CENTRAL FILE COPY TECHNICAL NOTE

Bureau of Land Management U.S. DEPARTMENT OF THE INTERIOR

FORD TRUCKS - PARTS AND SERVICE RECOMMENDATIONS, [part II]

Figure 1 - Parking Brake Lever "C" Series

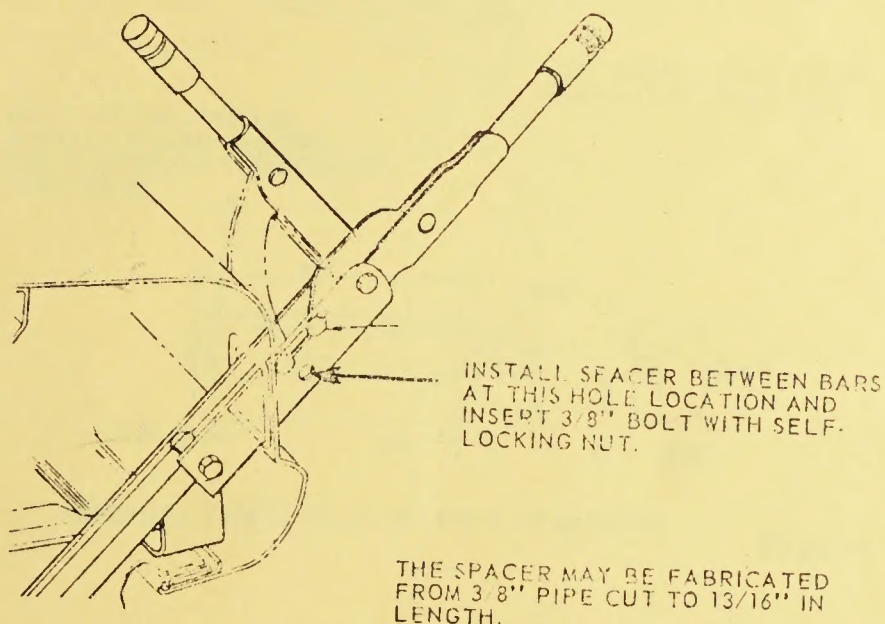
Effective September, 1968, the Orscheln parking brake lever on "C" Series trucks was revised by incorporating an additional spacer and rivet in the slot area between the two support bars. This change was made to reduce the possibility of the bars deforming if the parking brake lever is used as a grab handle when entering the cab.

The new lever is available for service under part number C5TZ-2780-B and can be identified by the presence of a rivet and spacer in the hole shown in Figure 1.

Parking brake levers on vehicles in service may be updated by inserting a spacer between bars and installing a 3/8" bolt and nut in place of the rivet used on production assemblies.

Figure 2

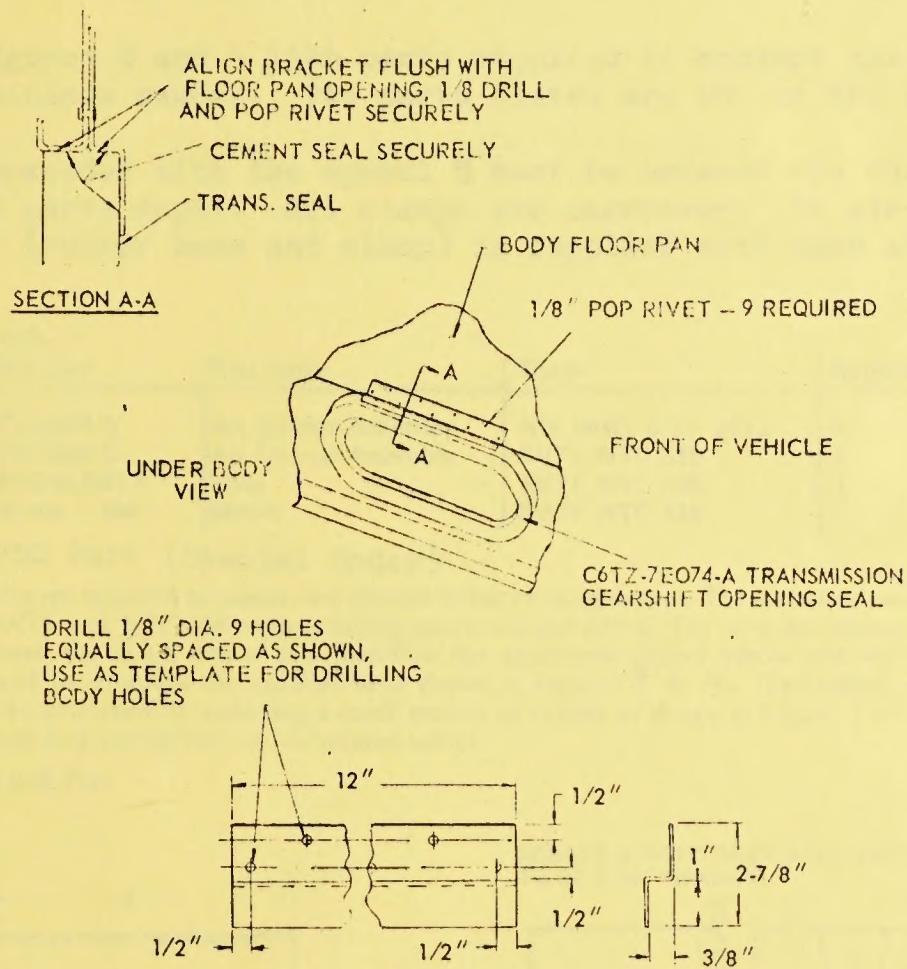
To correct water and dirt entry into the cab through the transmission gearshift lever opening when the seal is distorted, add a bracket to the underside of the body floor pan to provide additional support for the opening seal. Figure No. 2 includes all necessary information for fabrication and installation of the bracket.

A new opening seal, Part Number C6TZ-7E074-A, may also be required.

MATERIAL: 3-1/4" x 12" x 1/16" STEEL OR ALUMINUM

Figure 3

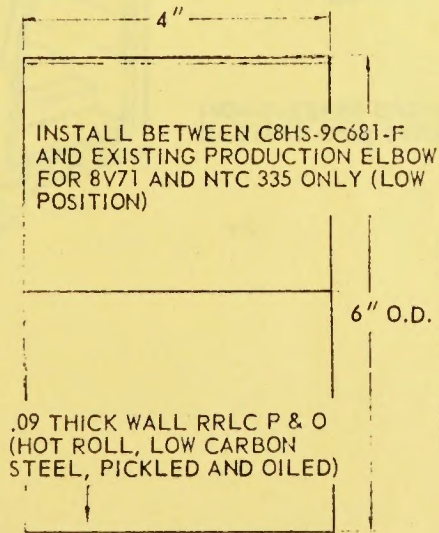
Chart 1 and Figures 3 and 4 list parts required to convert the oil bath air cleaner with minimum rework. The parts listed are DSO or RPO released.

* Parts are required to adopt new cleaner to the existing system. The oil bath cleaner for the 8V71 and NTC 335 engines incorporated a metal elbow. The new dry cleaner does not have the metal elbow and therefore the additional rubber elbow and sleeve are required to complete the installation as shown in Figures 3 & 4. The rubber elbow must be reworked by removing a small section of rubber as shown in Figure 7 to allow the hose to properly fit onto the cleaner outlet.

Figure 5

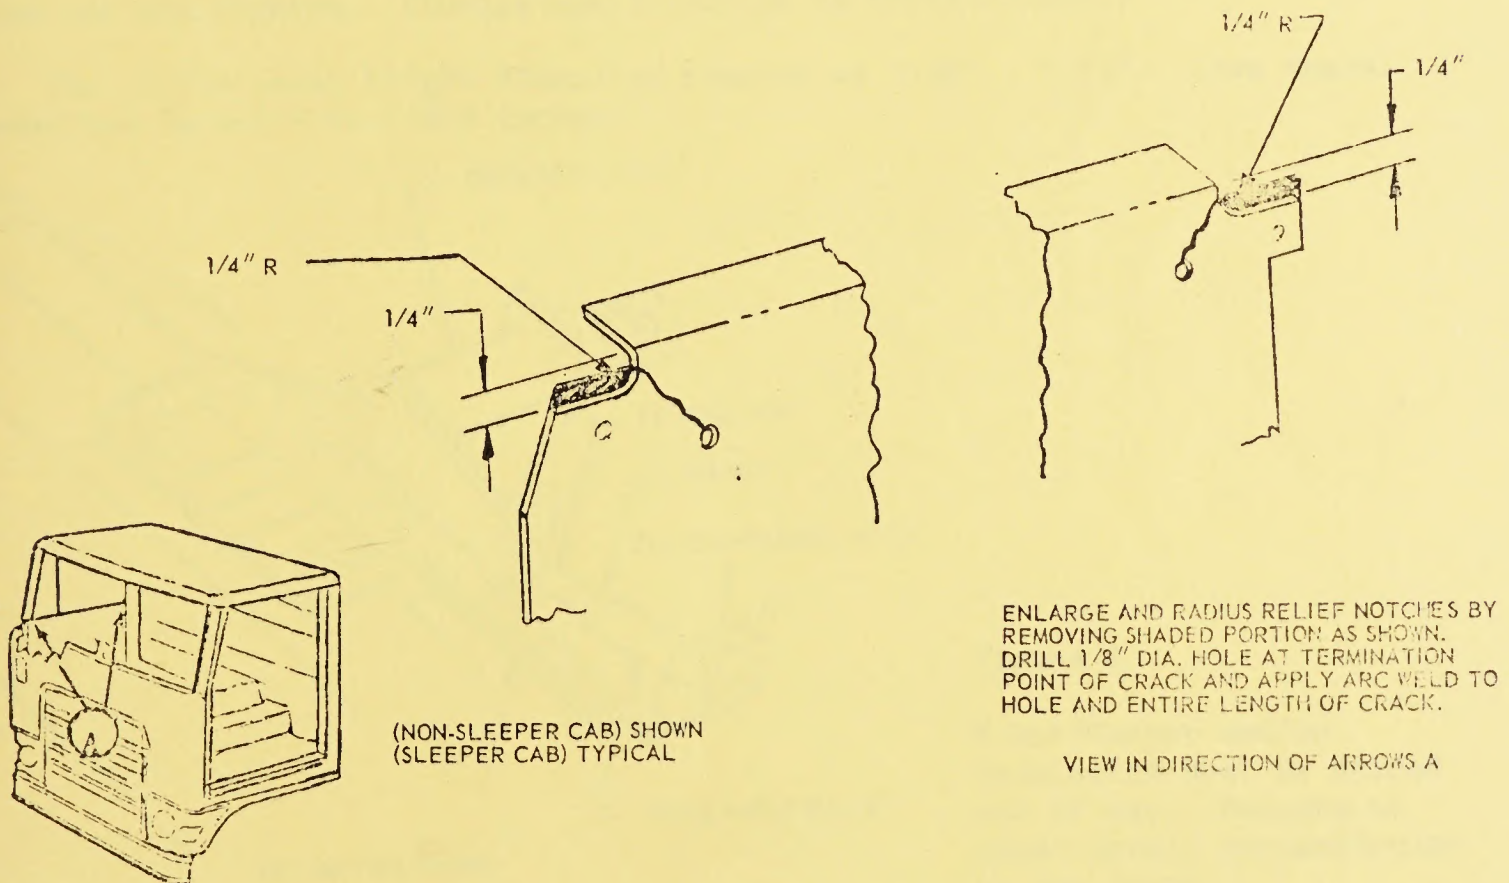
If sheet metal cracks occur at the front and rear belt relief notches of the door inner panels, the following procedure should be used. The production correction which enlarges the radius in the relief notches by removing metal from the vertical and horizontal trim lines was incorporated during July 1968.

1. Remove the door inner upper panel as described in the 1968 Truck Shop Manual, Volume Three, Page 17-54.
2. Drill a 1/8" diameter hole at the termination point of the sheet metal crack.
3. Enlarge and radius the front and rear belt relief notches on the door as shown in Figure 5.
4. Apply arc weld to the drilled holes and the entire length of the cracks.
5. Metal finish and repaint the repaired area as required.

Figure 6

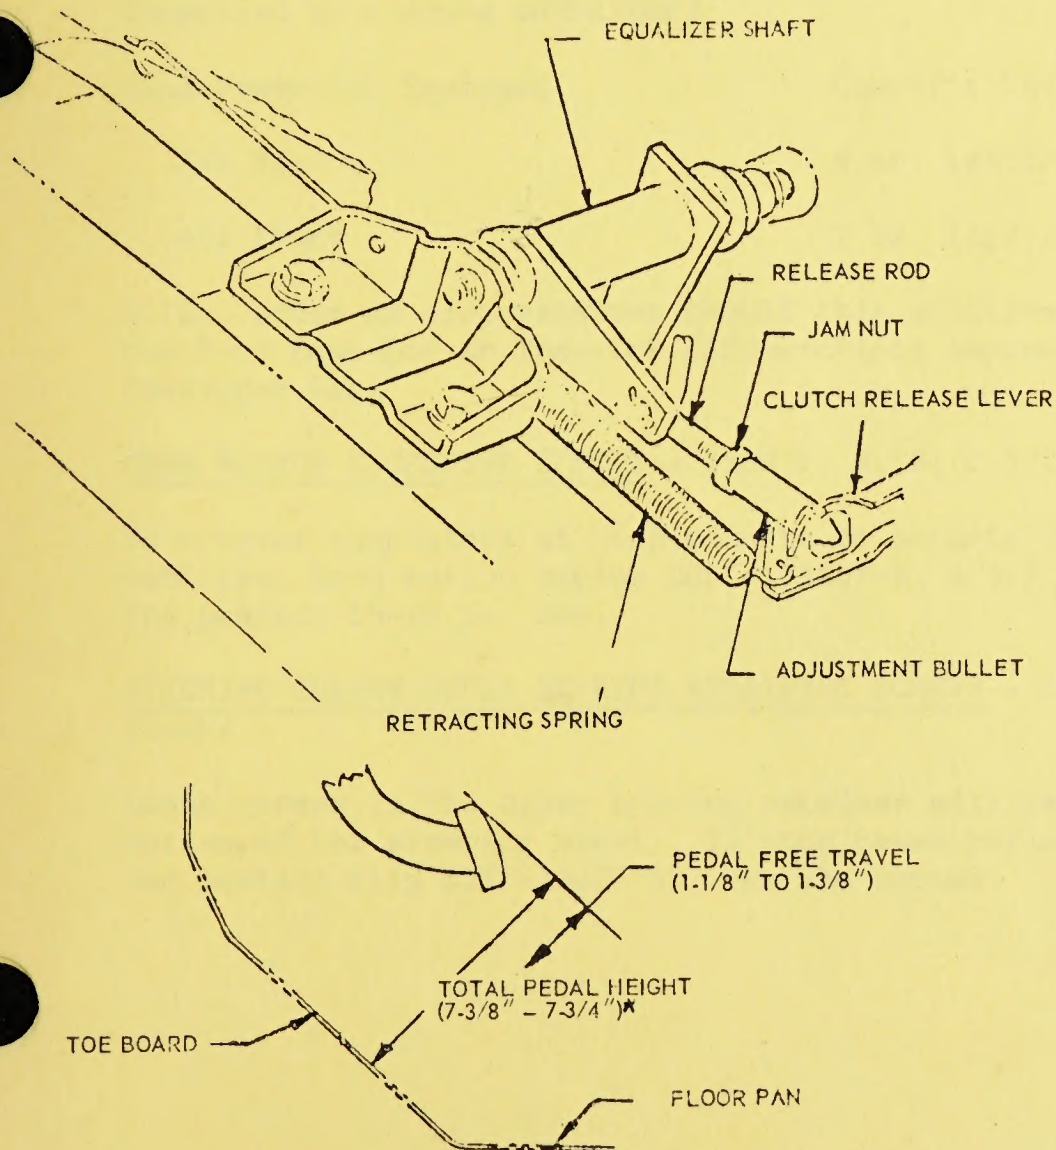
The clutch pedal "free travel" at the release rod "bullet" has been revised to .200 inch. To correctly adjust "free travel" follow this procedure:

1. Make sure the retracting spring is attached to the clutch release lever.
2. Loosen jam nut and back off five (5) or more turns.
3. Turn release rod "bullet" lightly against the clutch release lever facing. Use caution not to force "bullet" against the clutch release lever causing it to move against the retracting spring.
4. Place .200" gauge between the release rod "bullet" face and jam nut.
5. Return jam nut against gauge.
6. Remove gauge.
7. Hold jam nut in this position and rotate release rod "bullet" against the jam nut and tighten. (Torque specification is 12/18 ft.lbs.)

NOTE: The clutch pedal height dimension remains at 7.38" - 7.75". Free travel at pedal pad is 1-1/8 to 1-3/8 inches.
